NL-13-0545

**Joseph M. Farley Nuclear Plant**  
**Response to Request for Additional Information Concerning a Revision to the**  
**Technical Specifications Associated with the Low Temperature Overpressure**  
**Protection System and the Pressure-Temperature Limits Report**

**Response to Request for Additional Information (Non-Proprietary)**

**Figure 1: Comparison of FNP Unit 1 WCAP-17122-NP P-T Limits to Inlet Nozzle Limits**

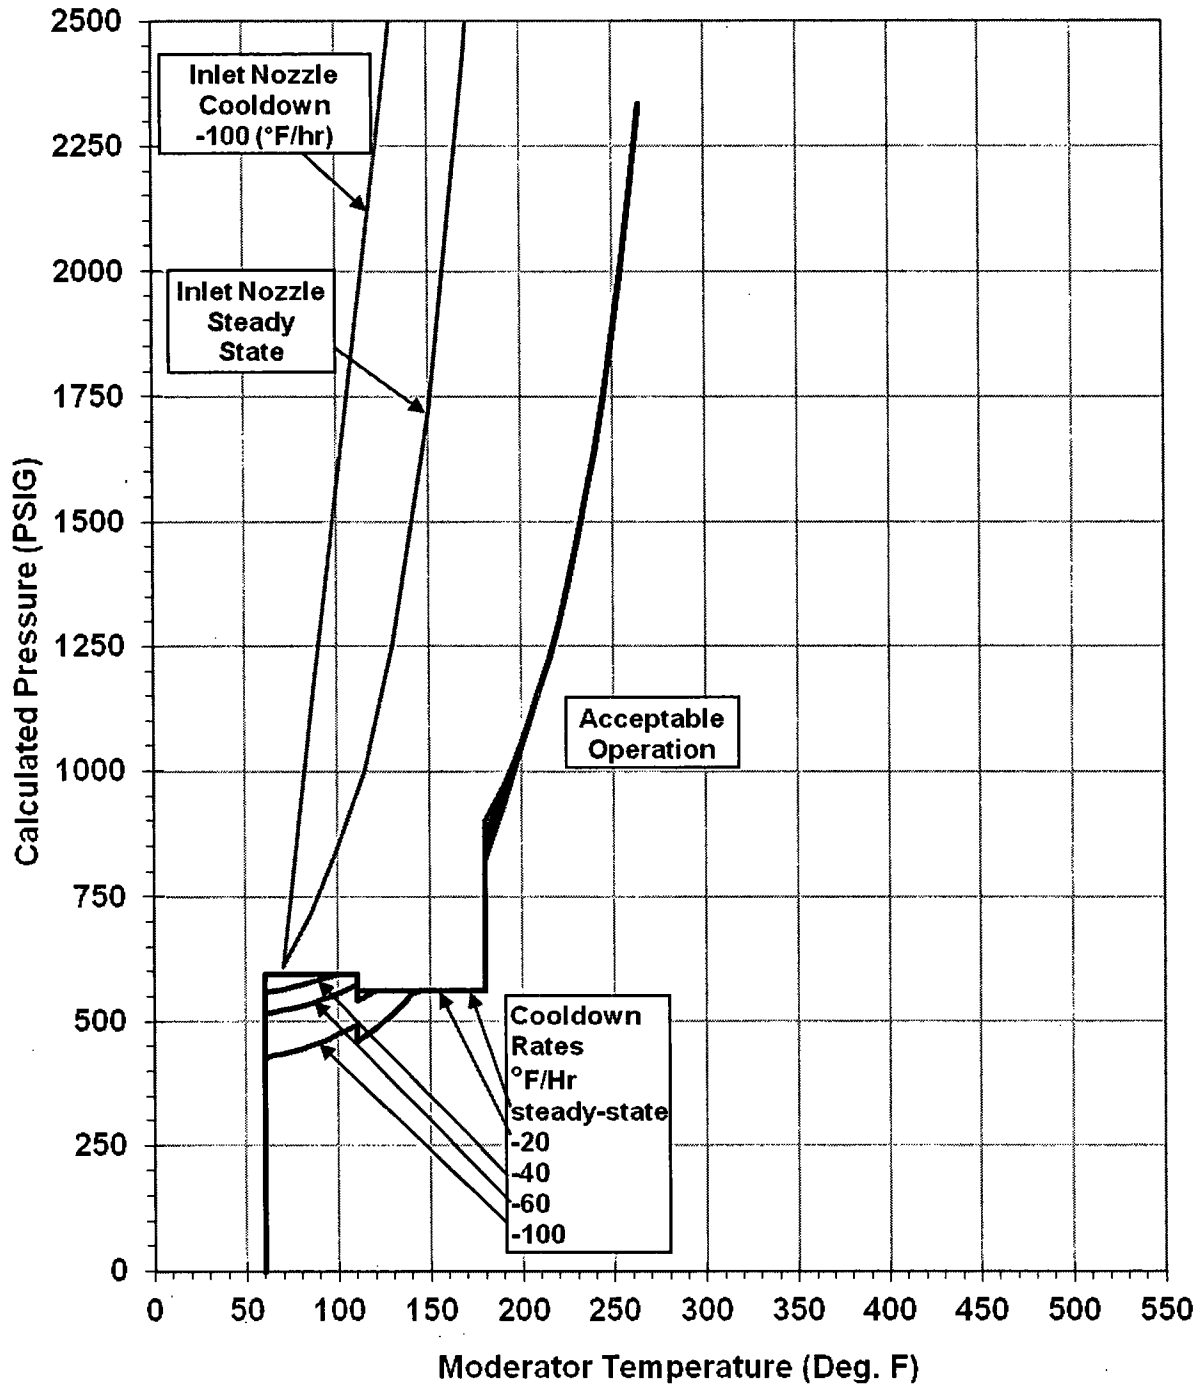
Discuss whether the proposed 54 effective full power years pressure-temperature limit curves, and the methodology used to develop these curves, considered all reactor vessel materials (beltline and non-beltline) and replacement ferritic reactor coolant pressure boundary materials (e.g. those installed subsequent to original construction for example, replacement steam generators), consistent with the requirements of Title 10 to the *Code of Federal Regulations*, Part 50, Appendix G.

The FNP Units 1 and 2 inlet and outlet nozzle P-T limit curves are shown in Figures 1 through 4, based on the stress intensity factor expression discussed above; also shown in these figures are the traditional beltline P-T limits from WCAP-17122-NP and WCAP-17123-NP. The nozzle P-T limits are provided for a cooldown rate of  $-100^\circ\text{F/hr}$ , along with a steady-state curve.

Based on the results shown in Figures 1 through 4, it is concluded that the nozzle P-T limits are bounded by the traditional beltline curves. Therefore, the P-T limits provided in WCAP-17122-NP and WCAP-17123-NP for 54 EFPY are still applicable for the beltline and non-beltline reactor vessel components.
